APPLICATION TO THE RESIDENTIAL DESIGN
AND COMPATIBILITY COMMISSION (RDCC)

GENERAL MODIFICATION WAIVER

STREET ADDRESS: 3700 LAWTON AVE

CITY OF AUSTIN – PLANNING AND DEVELOPMENT REVIEW DEPARTMENT
RESIDENTIAL PLAN REVIEW APPLICATION – MASTER COMMENT REPORT

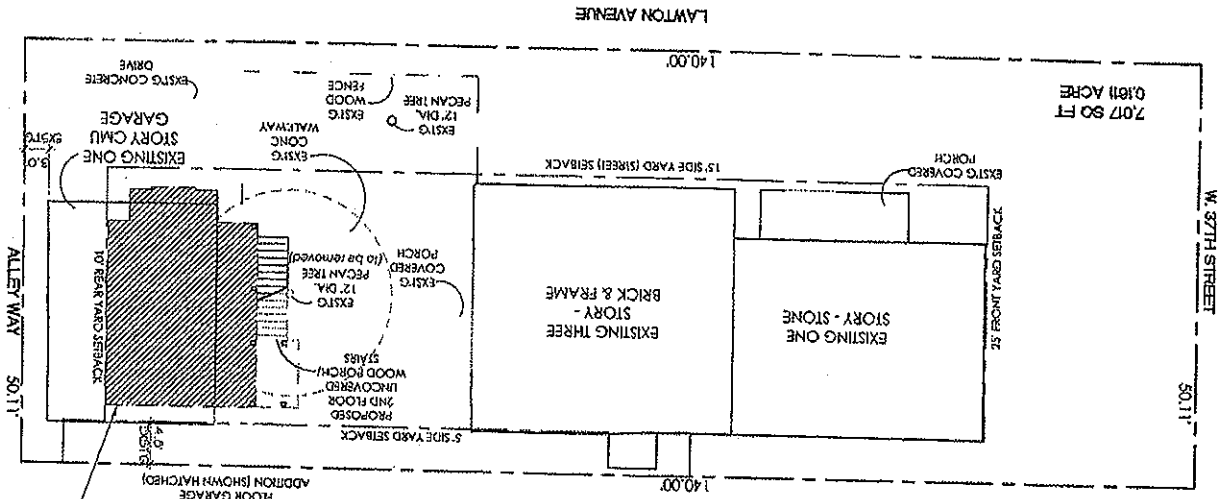
Comments: This tree is not protected size and does not require a permit.
- FYI, the proposed plan would require either severe canopy pruning or complete removal of the tree. The plan is not recommended if the

☐ Heritage Tree(s) applicant wishes to preserve the tree.

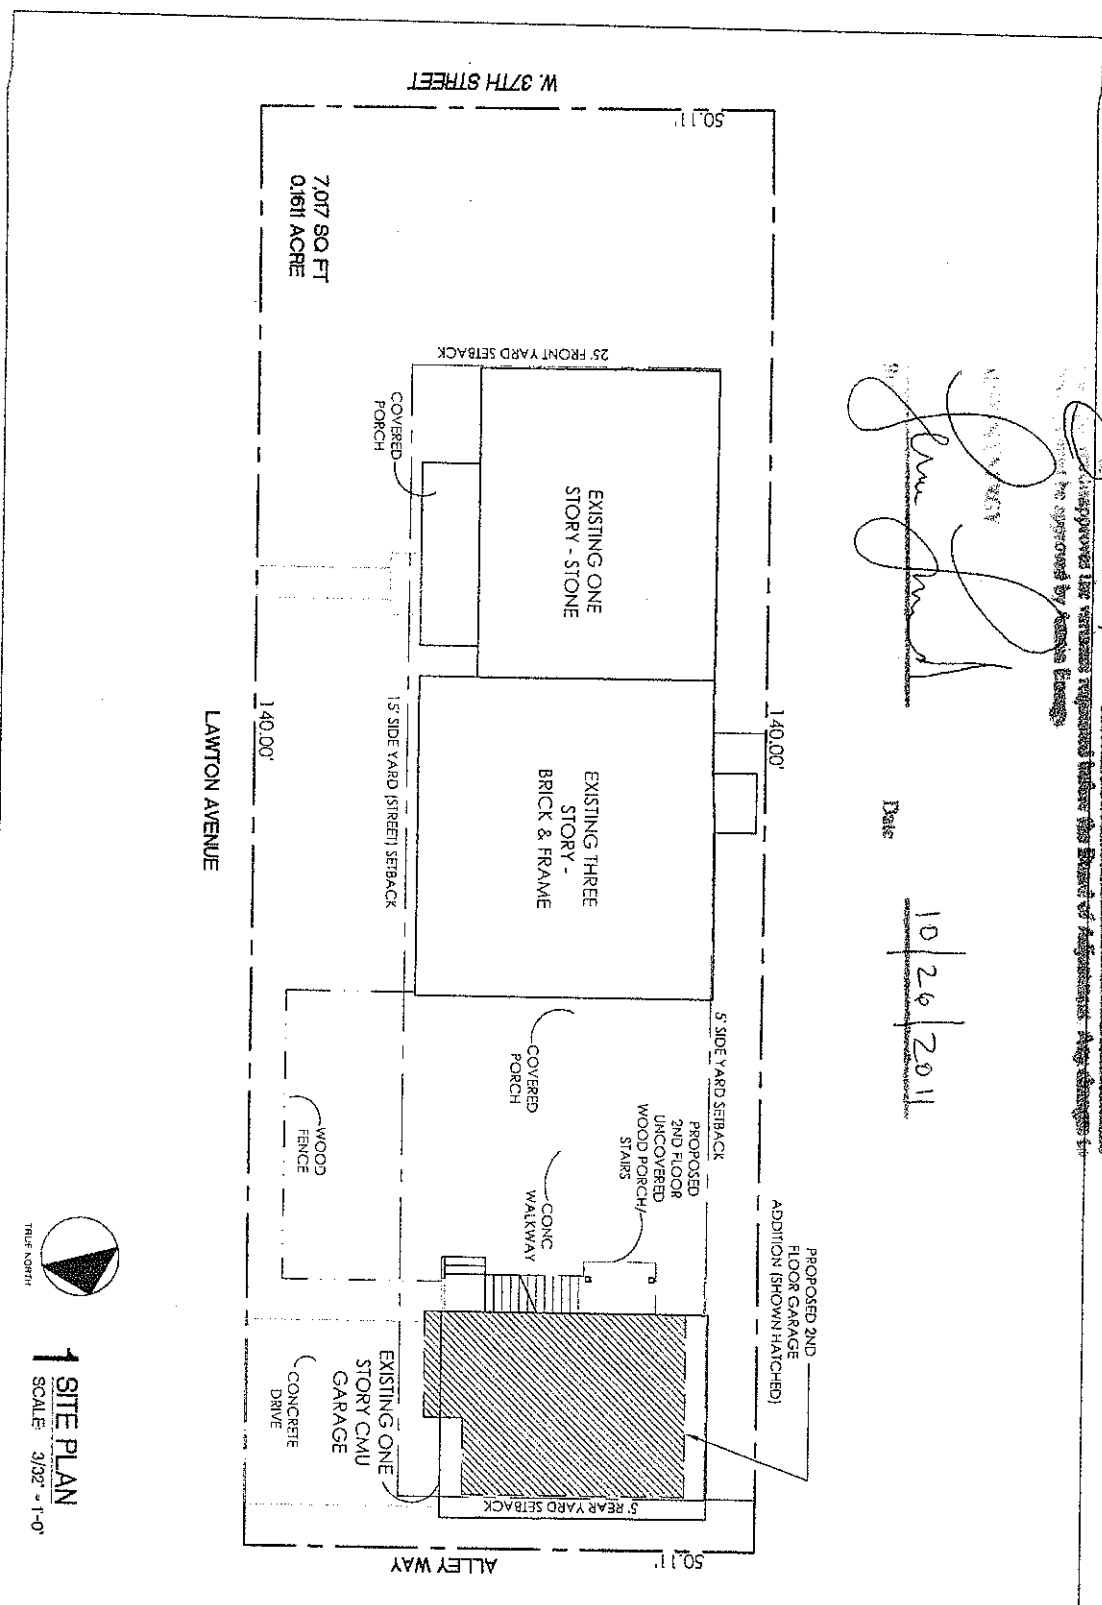
Austin Energy (AE) has reviewed your application for the above referenced property requesting to reduce the rear setback adjacent to the alley from 10 ft to 5 ft in order to erect a 2nd story garage apartment. Austin Energy has no conflicts with this application as requested and shown on the attached red-stamped sketch.

As received this plan for 3700 Lawton Ave
 Approved for variance requested under the Board of Adjustment. Any changes to
 must be approved by Sarah McIntyre.
